Subject: Housing Element updates

Subject: 7C. Housing Element Zoning Amendments

Subject: Housing Element – Proposed zoning text amendments for Park Street and Webster Street (Item 7-C on 2-14-22 Planning Board agenda)

MF (MULTI FAMILY) ZONE 1
HISTORIC CORE
CENTRAL AVE TO LINCOLN AVE

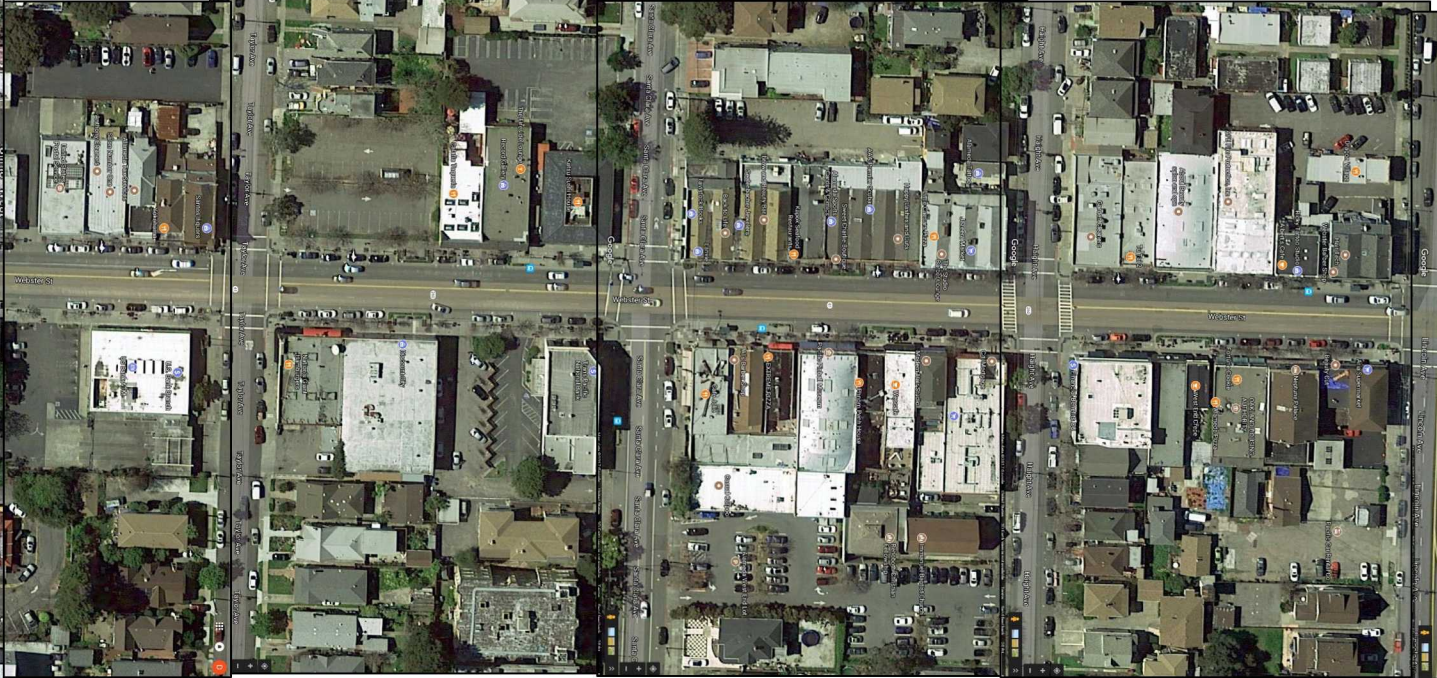
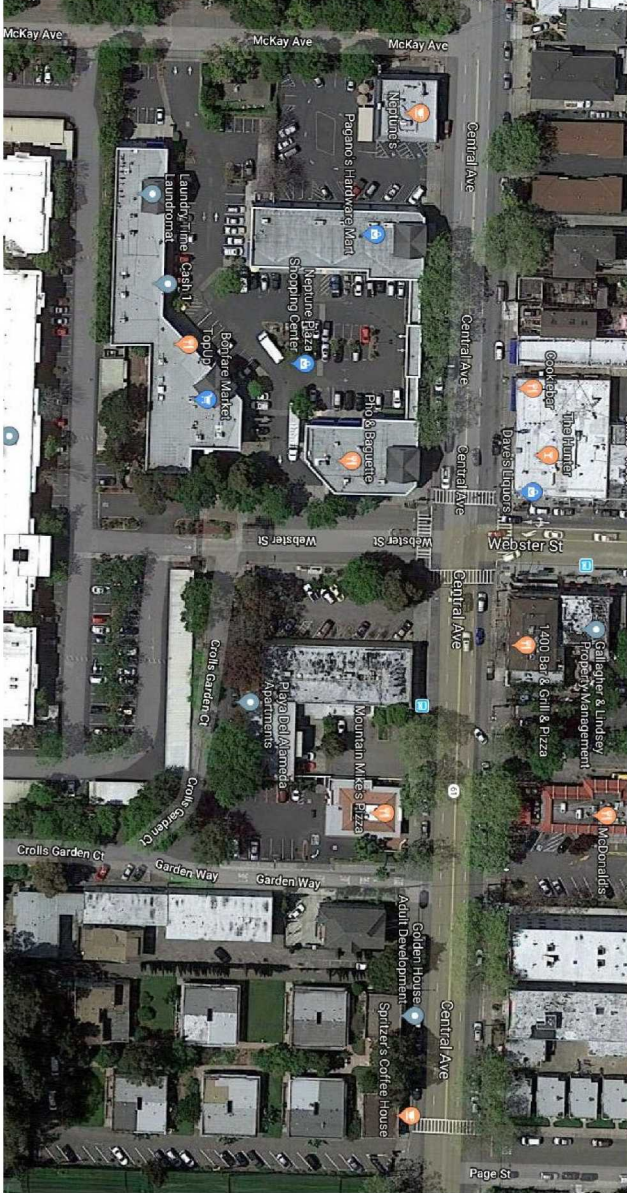
1. NO CHANGES TO NUMBER OF FLOORS ALLOWED
2. INCREASE HEIGHT ALLOWANCE TO 45'
3. MAINTAIN DENSITY LIMIT OF 22 RESIDENTIAL UNITS PER ACRE IF SDBO USED OR USE "FORM BASED CODE" DENSITY (WHATEVER FITS INTO THE BUILDING WITHIN THE ALLOWED HEIGHT), IF NO SDBO USED.
4. REDUCES PARKING REQUIREMENT

1. NUMBER OF FLOORS ALLOWED GRADUALLY INCREASES (CURRENTLY 3 FLOORS)
2. INCREASE HEIGHT ALLOWANCE TO 45' (CURRENTLY 40') THEN GRADUALLY INCREASES HEIGHT PER DIAGRAM.
3. MAINTAIN DENSITY LIMIT OF 22 RESIDENTIAL UNITS PER ACRE IF SDBO USED OR USE "FORM BASED CODE" DENSITY (WHATEVER FITS INTO THE BUILDING WITHIN THE ALLOWED HEIGHT), IF NO SDBO USED.
4. REDUCES PARKING REQUIREMENT

- 45' HT ALLOWED @ STREET FRONT WITH 3 FLOORS
- 55' HT ALLOWED @ SIGHT LINE SETBACK WITH 4TH FLOOR

- 55' HT ALLOWED @ STREET FRONT WITH 4 FLOORS

- 55' HT ALLOWED @ STREET FRONT WITH 4 FLOORS
- 65-70' HT ALLOWED @ SIGHT LINE SETBACK WITH 5 FLOORS

- 55' HT ALLOWED @ STREET FRONT WITH 4 FLOORS
- 65-70' HT ALLOWED @ SIGHT LINE SETBACK WITH 5 FLOORS
- ±77' HT ALLOWED @ SIGHT LINE SETBACK WITH 6TH FLOOR

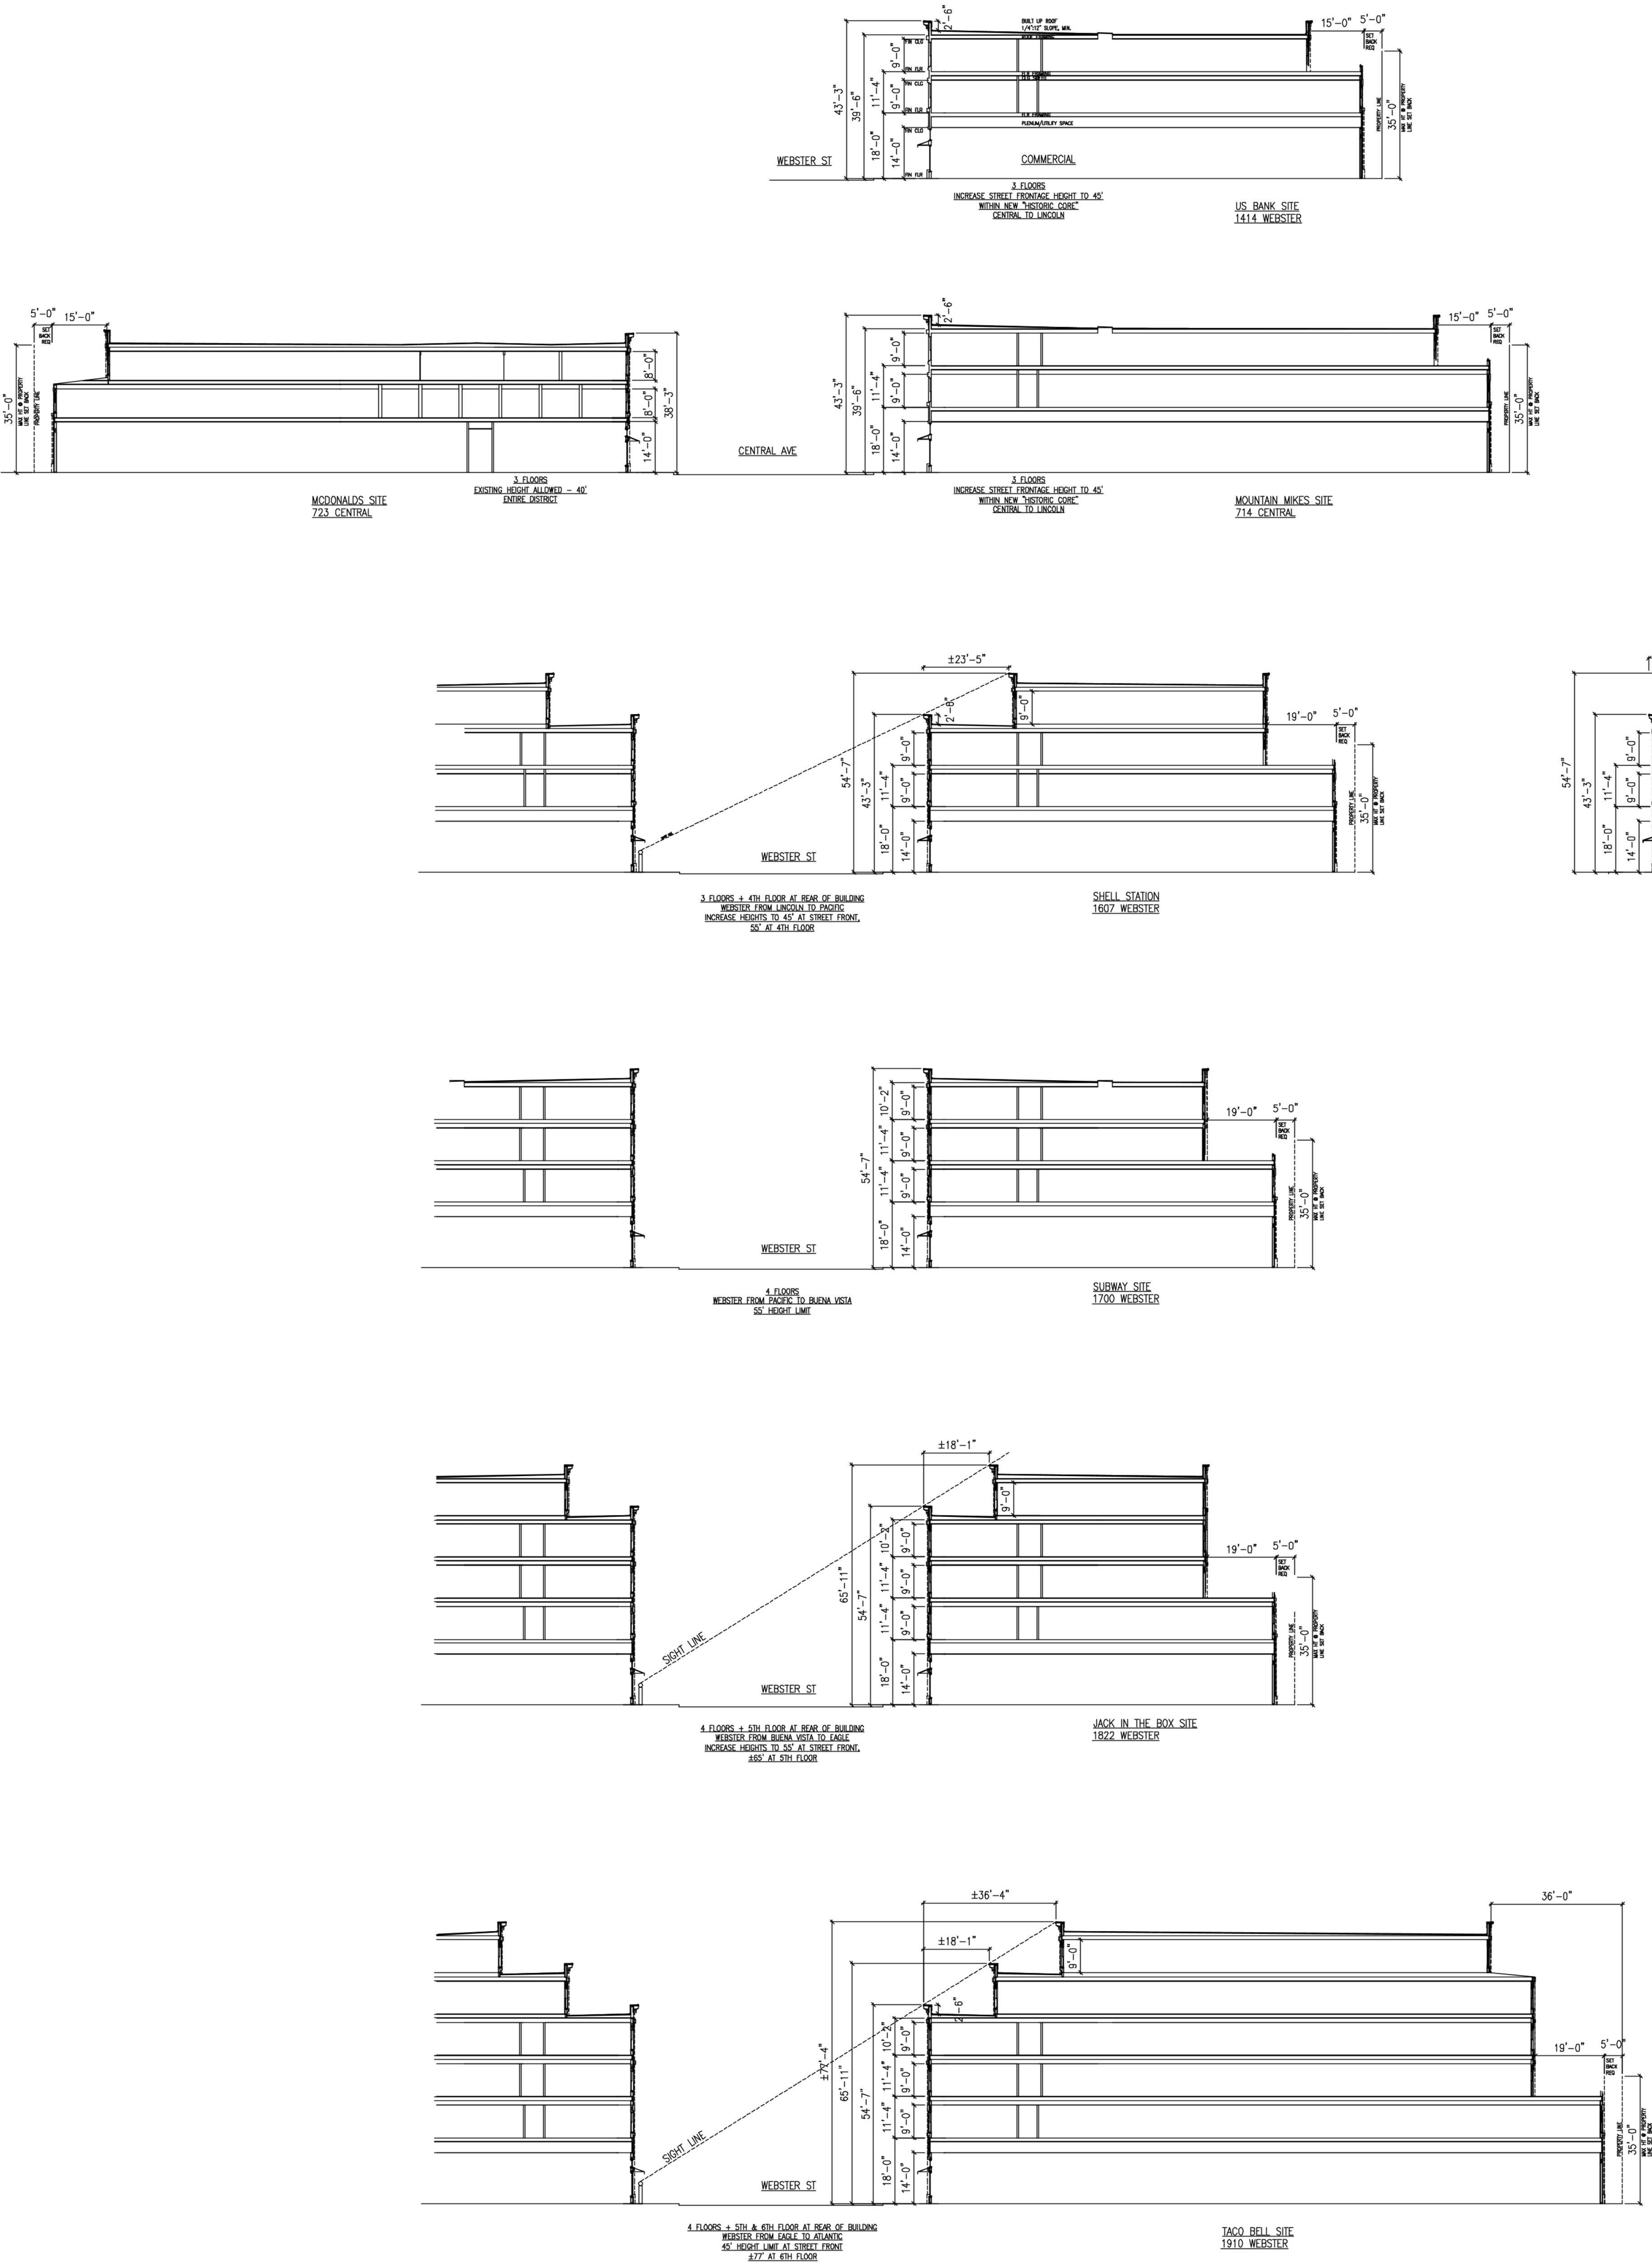
- Properties fronting onto the south side of Central Avenue - fifty five (55') feet, provided that any portion of the building that exceeds forty five (45') feet is set back at least ten (10') feet from the face of the building.
- Properties fronting onto Webster Street between Central Avenue and Lincoln Avenue, and properties fronting onto the north side of Central and south side of Lincoln - forty five (45') feet;
- Properties fronting onto Webster Street between Lincoln Avenue and Pacific Avenue and properties fronting onto the north side of Lincoln and the south side of Pacific - fifty five (55') feet, provided that any portion of the building that exceeds forty five (45') feet is set back at least ~~ten (10')~~ feet from the face of the building;

- Properties fronting onto Webster Street between Pacific Avenue and Buena Vista Avenue and properties fronting onto the north side of Pacific and the south side of Buena Vista Avenue - fifty five (55') feet; (SAME 24' SET BACK? @ REAR?)

- Properties fronting onto Webster Street between Buena Vista Avenue and Eagle Avenue and properties fronting onto the north side of Buena Vista or the south side of Eagle- sixty five (65') feet, provided any portion of the building that exceeds fifty five (55') feet is set back at least ~~ten (10')~~ ^{18'} feet; and, (+ 24' SET BACK @ REAR @ ?)

- Properties fronting onto Webster Street between Eagle Ave and Atlantic Avenue and properties fronting onto the north side of Eagle or south side of Atlantic- eighty five ~~(85') feet.~~ ^{80' w/ 18' SET BACK @ 5TH FLR + 36' SET BACK @ 6TH FLR + 24' @ REAR}

2022-01-31
match rear setbacks to
duplicate front setbacks
